DEPARTMENT OF TRANSPORTATION**Federal Aviation Administration****14 CFR Part 36**

[Docket No. FAA-2000-7958; Notice No. 00-11]

Noise Certification Regulations for Helicopters

ACTION: Notice of Proposed Rulemaking (NPRM).

Figure H1.
Comparison of Measured and Reference Takeoff Profiles

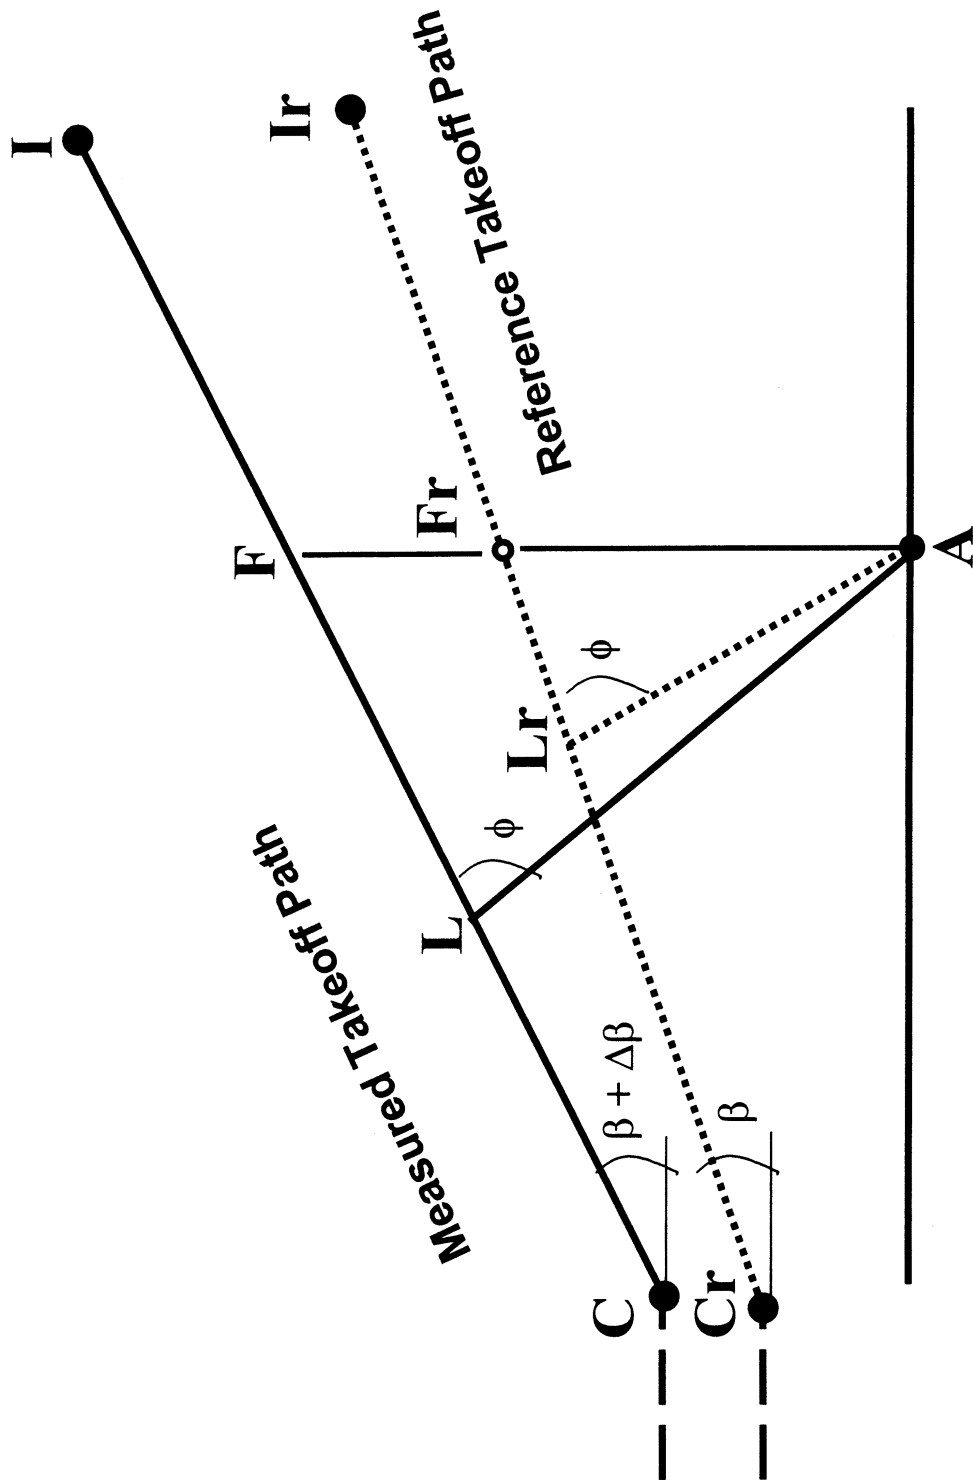
Proposed revision to Figure H1 deletes the designation of Positions Tr since the minimal distance designation is no longer needed and includes the height above measurement point in metric units; see the text of proposed section H36.205(b)(3) regarding the takeoff condition.

In proposed Figures H1, H2, and H3 the titles of the figures are changed to reflect the language of this proposal. The word "reference" would replace the word "corrected" in each title.

Figure H2.
Comparison of Measured and Reference Flyover Profiles

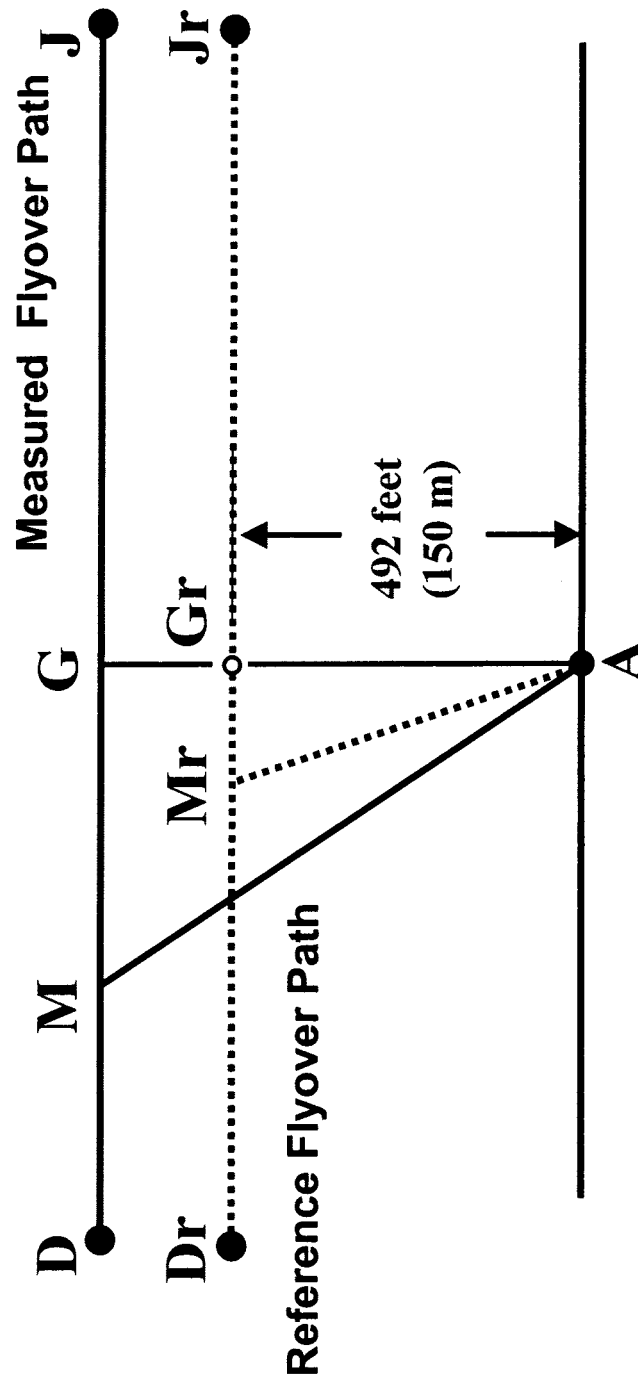
Proposed revision to Figure H2 repositions the bullet-marker that's incorrectly positioned near label G due to a typographical error. The marker is repositioned in the proposed revised graphic image at the intersection of line Dr-Jr and line A-G.

Figure H3.
Comparison of Measured and Reference Approach Profiles

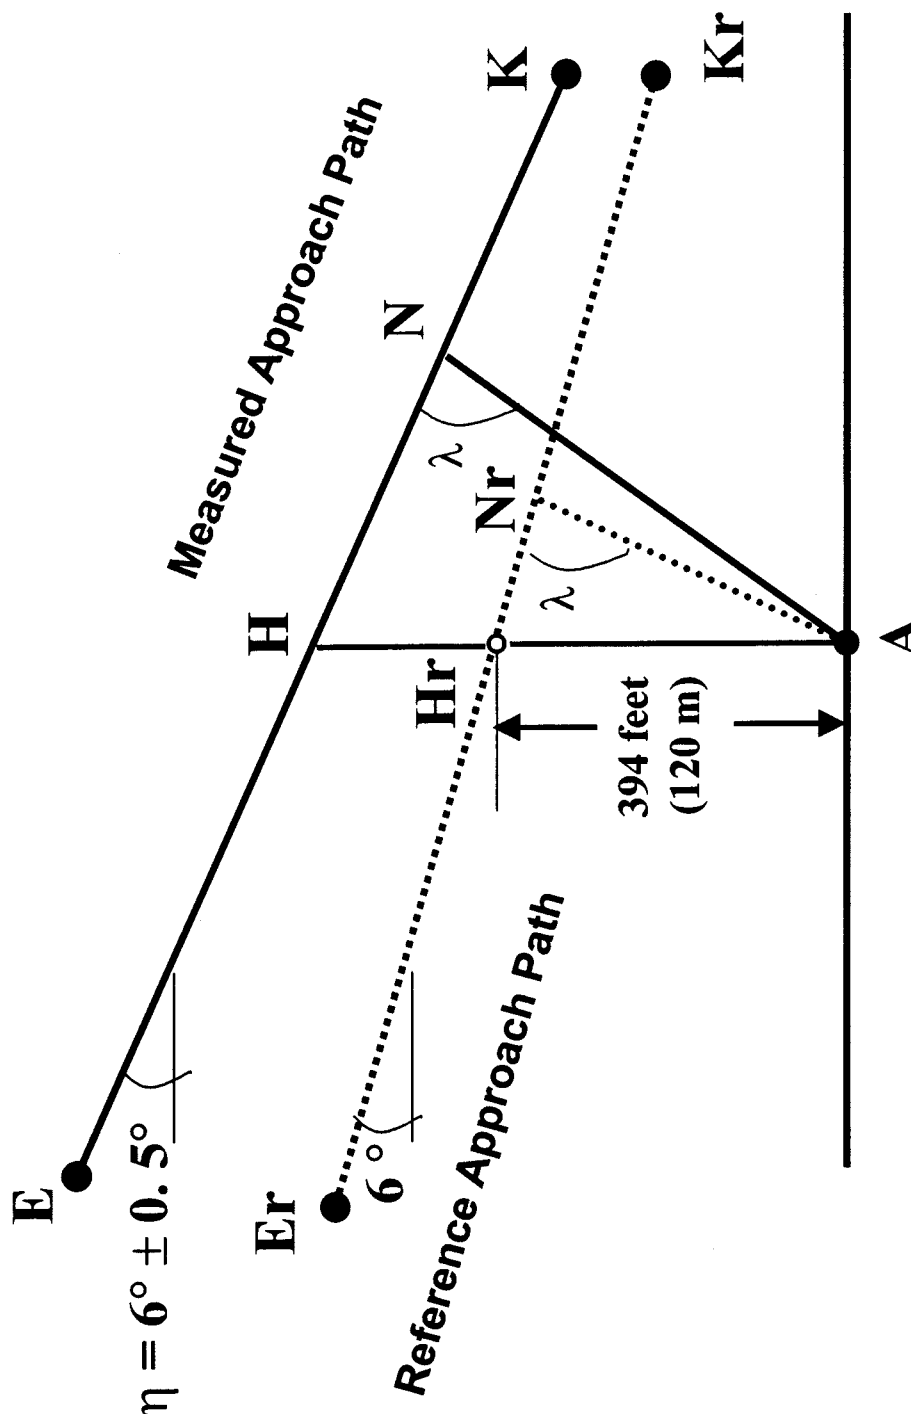
Proposed section H36.205(d)(3) removes the minimal distance description from the reference to figure H3. This description is no longer needed given the proposed change to section H36.205(a)(3)(iii).

Proposed revision to Figure H3 deletes the designations of Positions S and Sr since the minimal distance designation is no longer needed and includes the height above measurement point in metric units; see the text of section H36.205(d)(3) regarding the approach condition.
